# 2714 DUNSMUIR, CUMBERLAND

## HERITAGE ALTERATION PERMIT AMENDMENT

2022.09.06

Client:  
Postmark Group

# WHY HAP AMENDMENT?

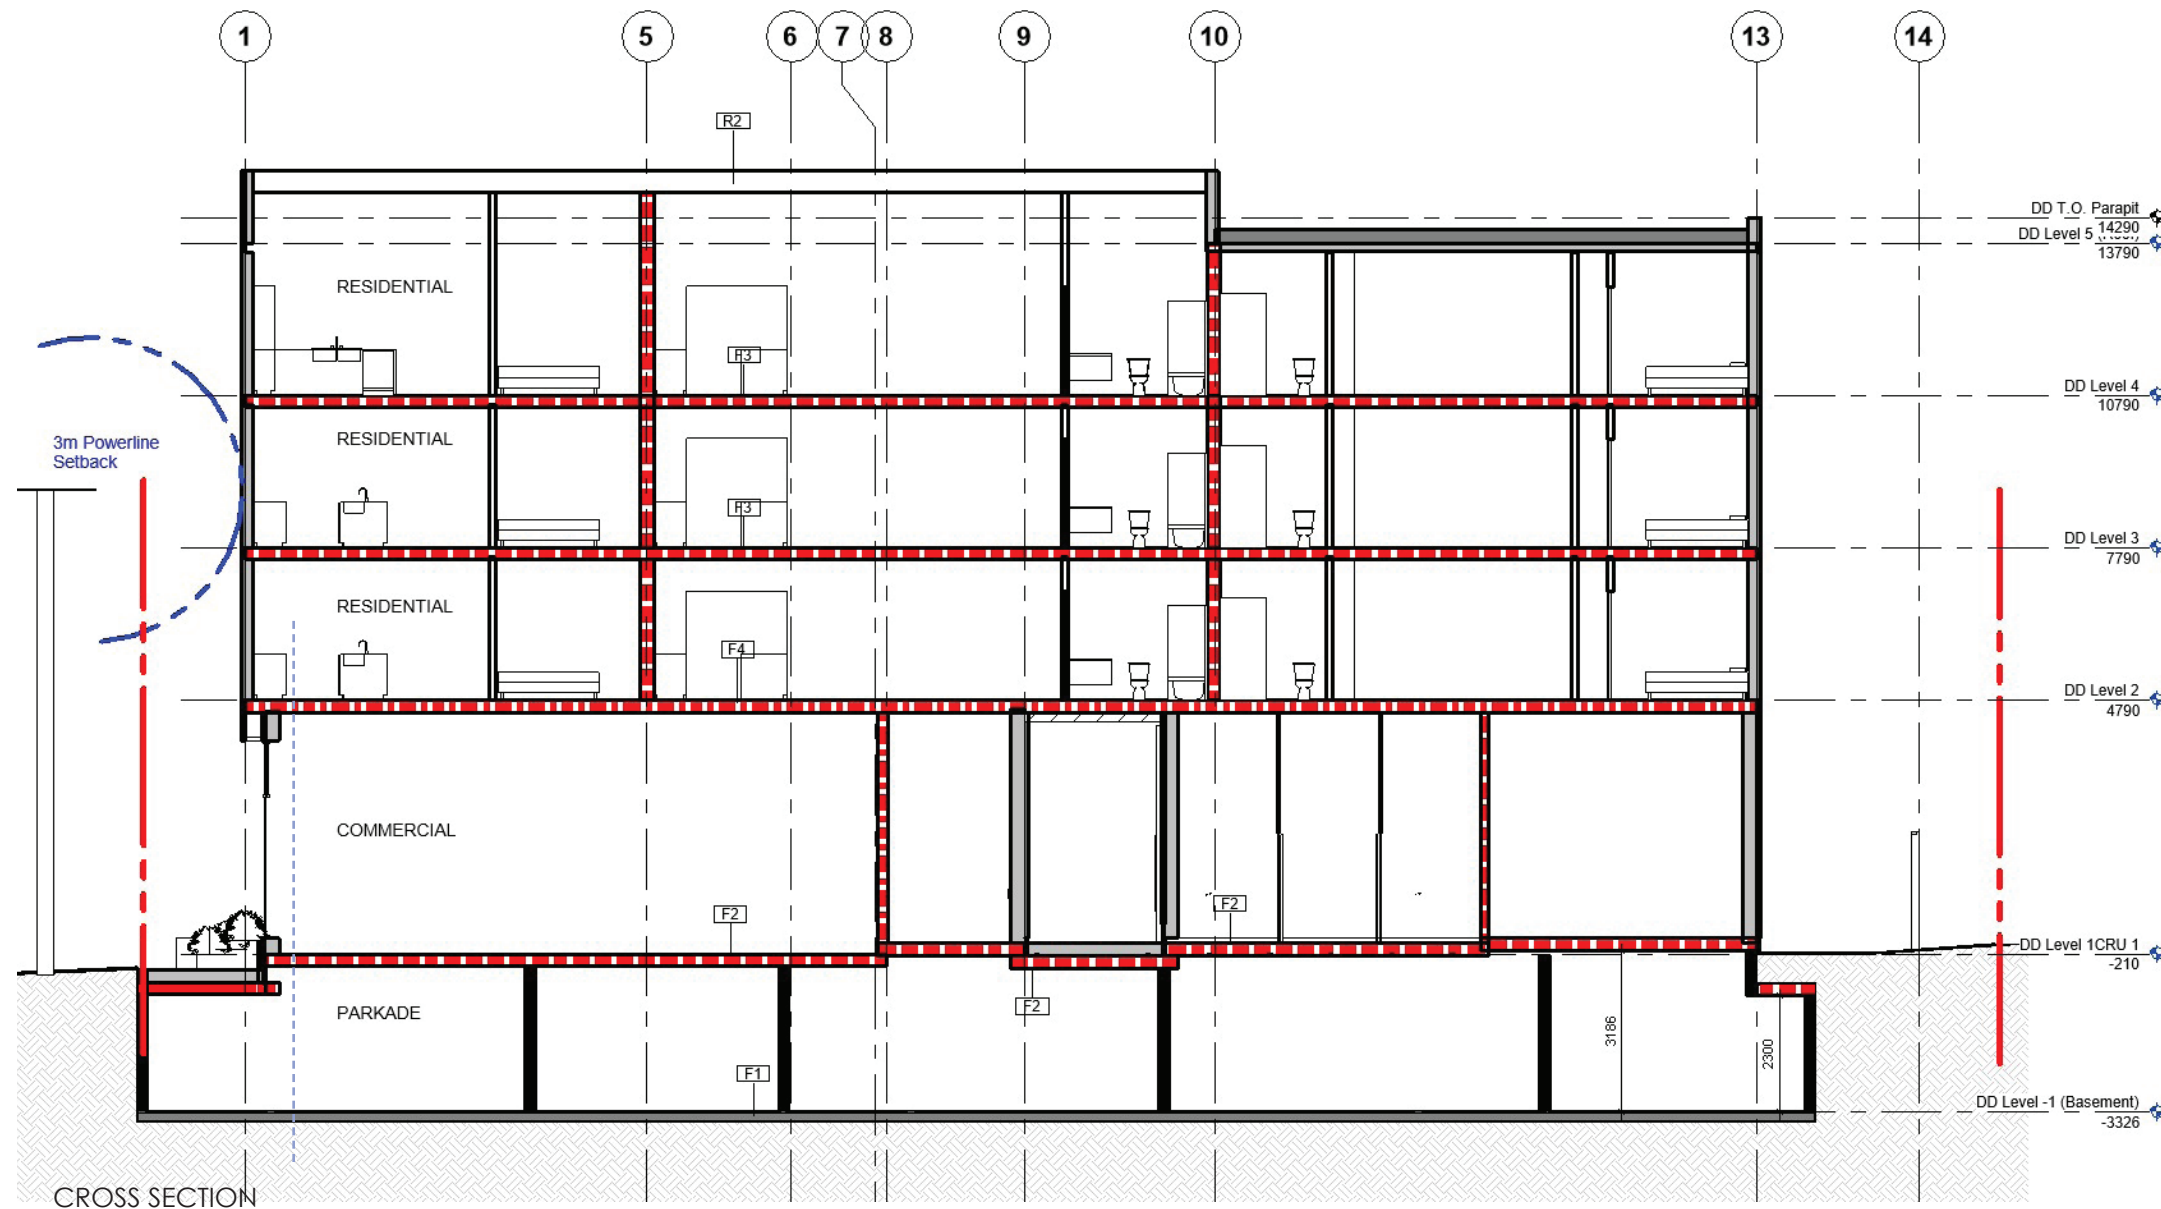
1/ WITH RESPECT TO THE ORIGINAL DP DESIGN THE MASSING OF THE BUILDING HAS BEEN AMENDED DUE TO AN ELECTRICAL SETBACK (3M FROM POWER LINES)

2/ THE CORNER MASSING HAS BEEN RECESSED BY 2.06M

3/ THE LOT COVERAGE REMAIN IDENTICAL (68%) AND THE DENSITY HAS BEEN INCREASED TO FSR : 2.0

4/ THE RESIDENTIAL ENTRANCE HAS BEEN REDUCED IN SIZE AND CHANGED THE 2 STAIRS INTO A SCISSOR STAIR THAT REQUIRES LESS FLOOR AREA

5/ THE CLADDING MATERIALS HAVE BEEN CHANGED DUE TO A CODE REQUIREMENT TO HAVE A NON-COMBUSTIBLE CLADDING ON THE INTERIOR LOT LINE. THE EXISTING COMBUSTIBLE CHARRED-LOOK WOOD VERTICALLY INSTALLED SIDING HAS BEEN REPLACED BY A NON-COMBUSTIBLE BLACK CORRUGATED METAL PANEL, VERTICALLY INSTALLED.

# MAIN FLOOR PLAN - MEZZANINE

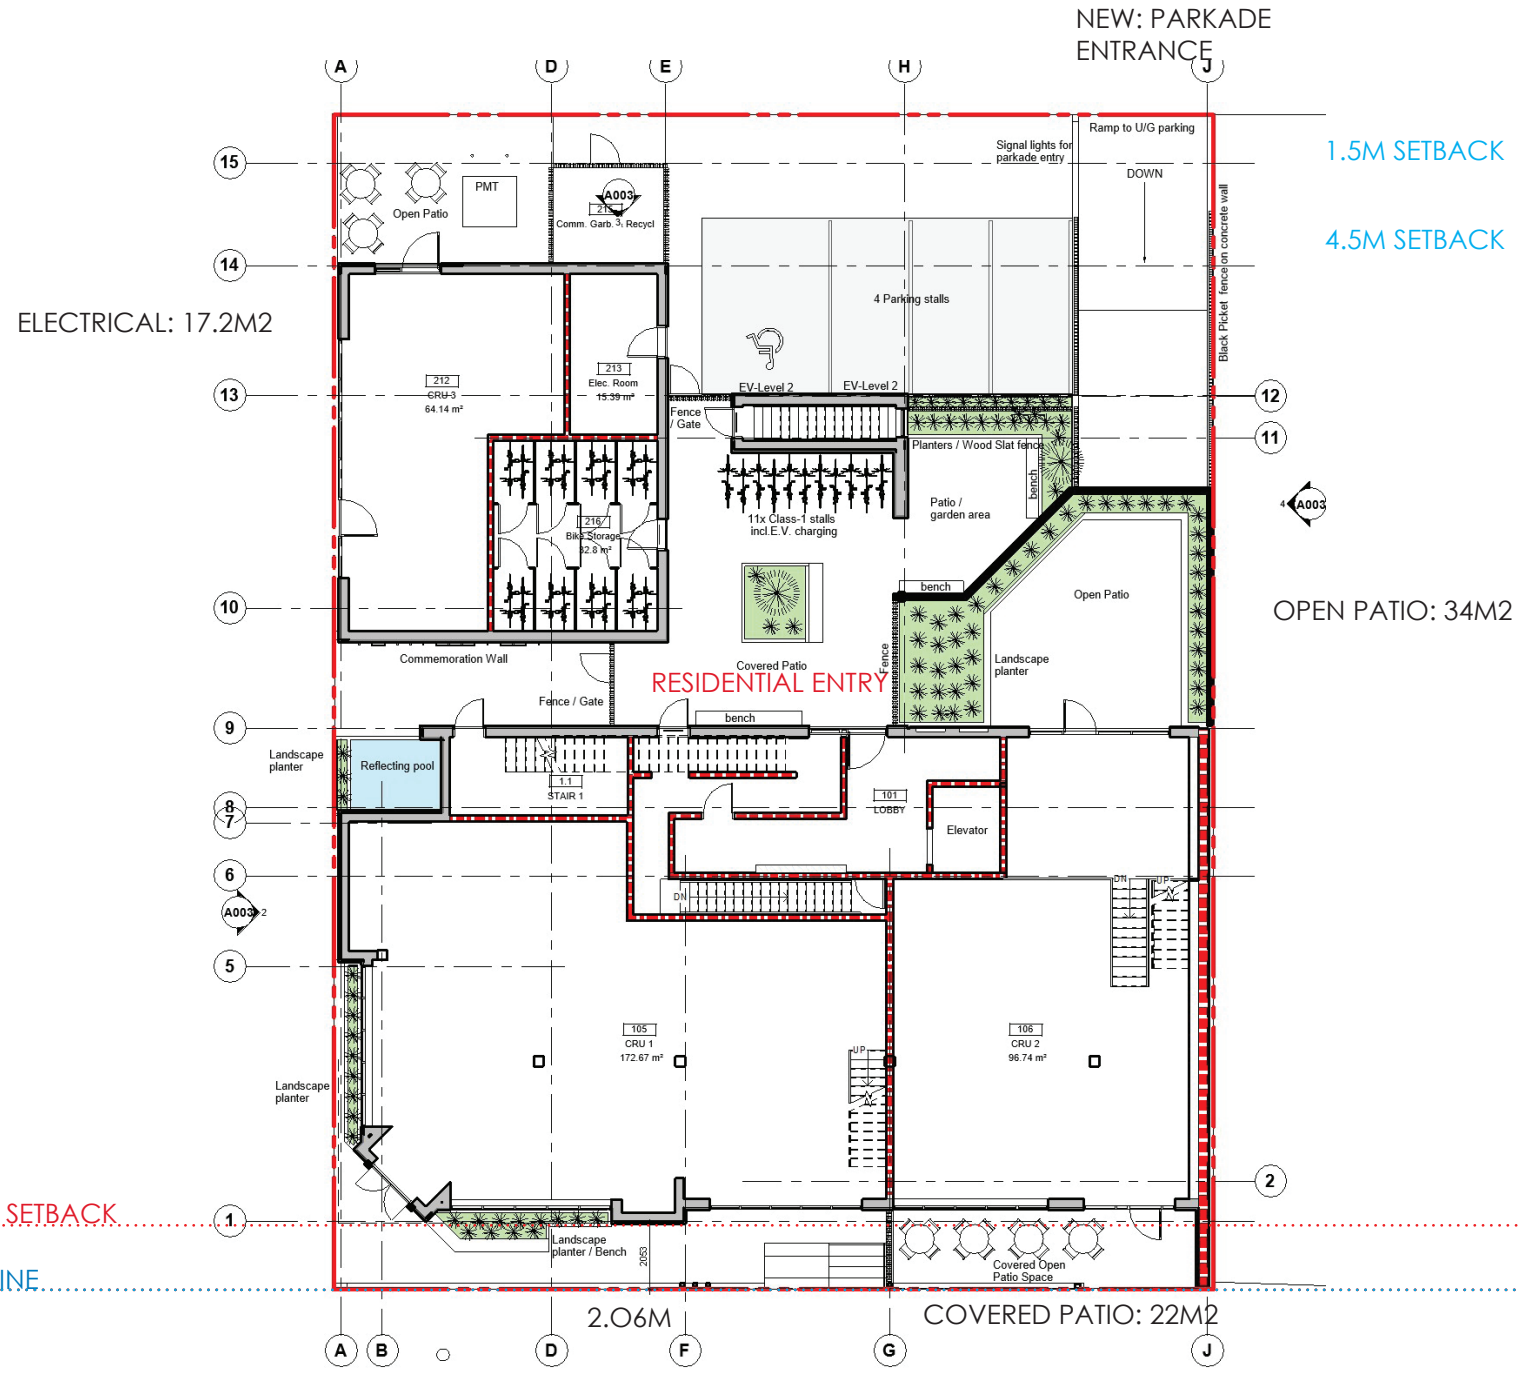
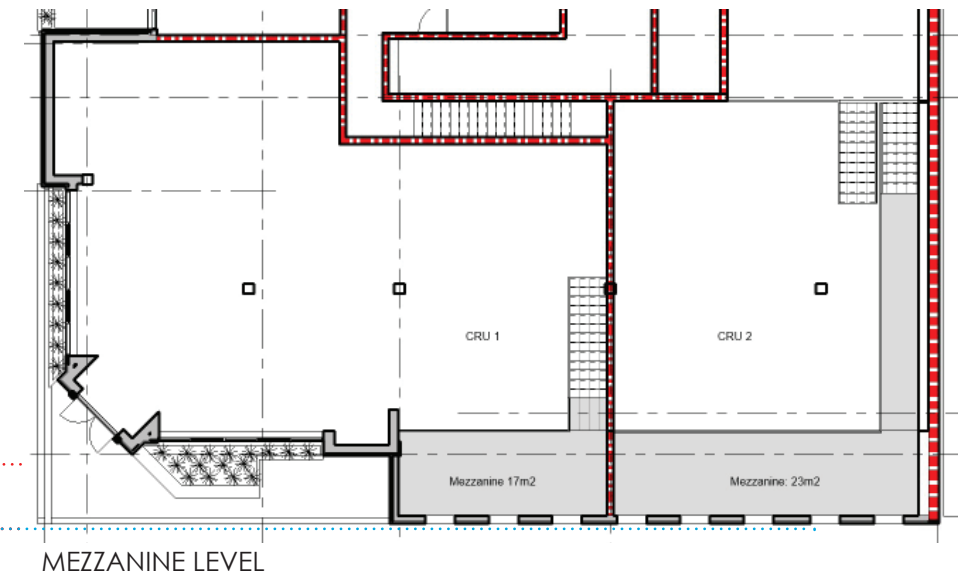
FRONT SETBACK:  
 - REQUIRED: MIN. 0M  
 MAX 1.0M FOR A MIN OF 75 % OF THE BUILDING FACADE  
 - PROPOSED: 0-2.06M \*\*  
 \*\* VARIANCE REQUESTED

SETBACK DUE TO HYDRO LINE  
 SINGLE RESIDENTIAL MAIN ENTRANCE IN COURTYARD

# 2ND FLOOR PLAN

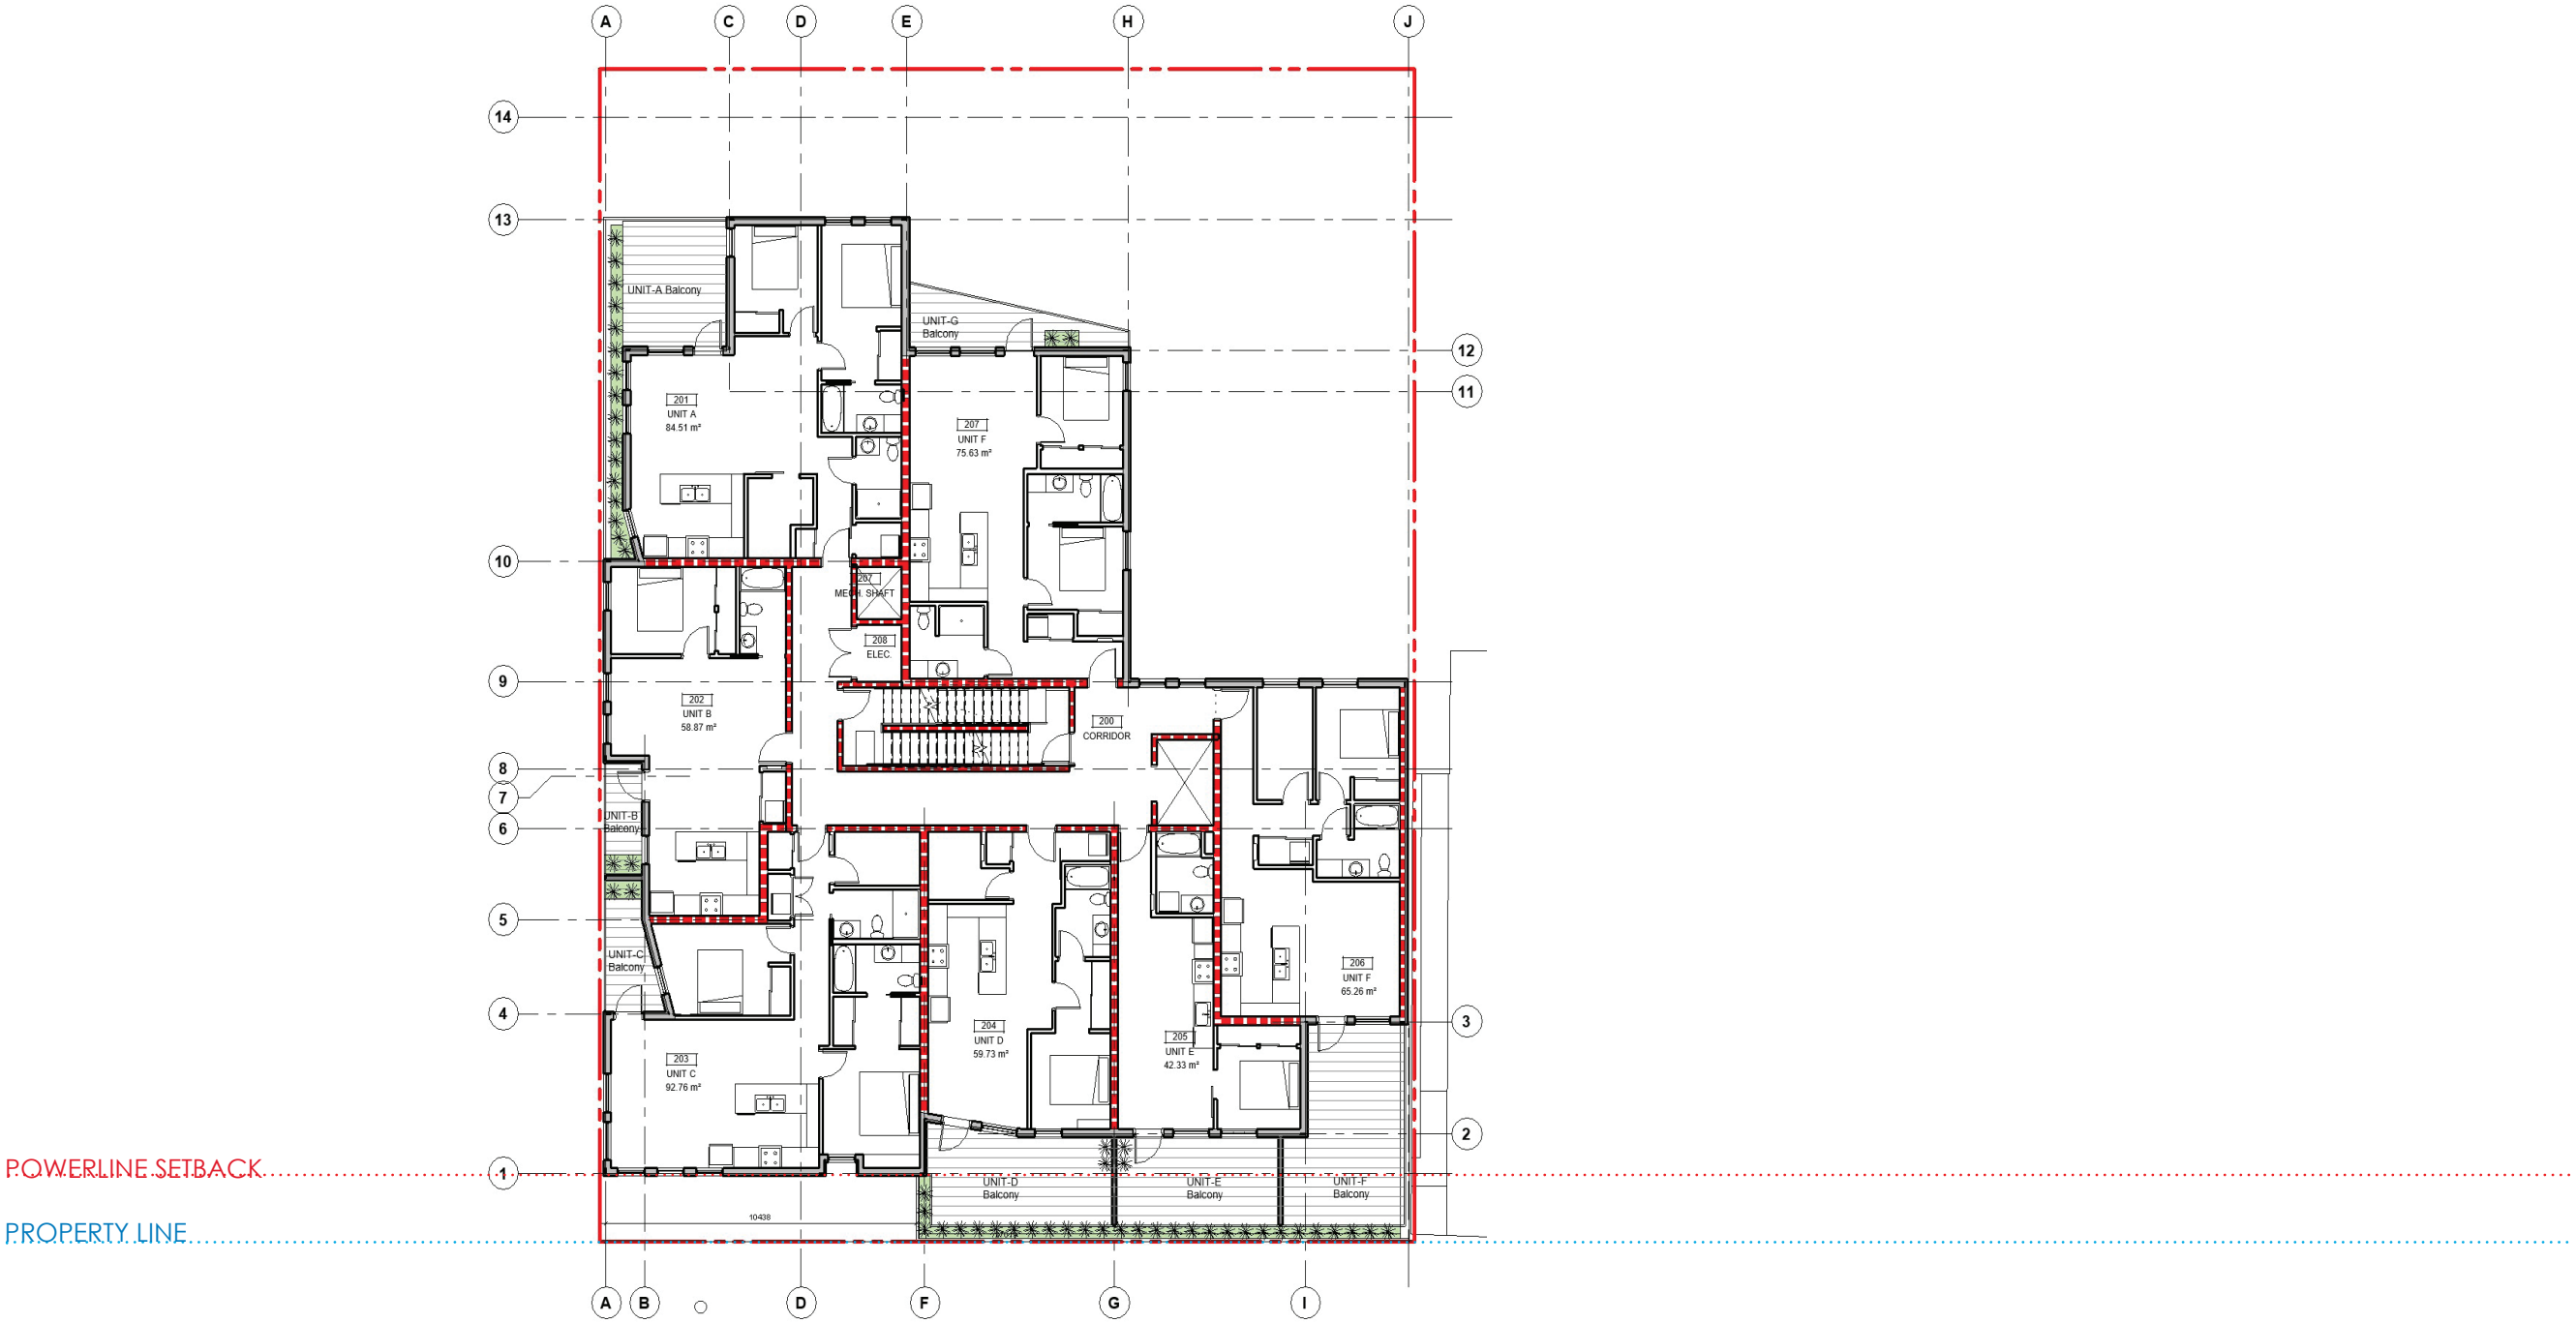
FOOTPRINT WAS BEEN INCREASED  
2 EXTRA UNITS PER FLOOR
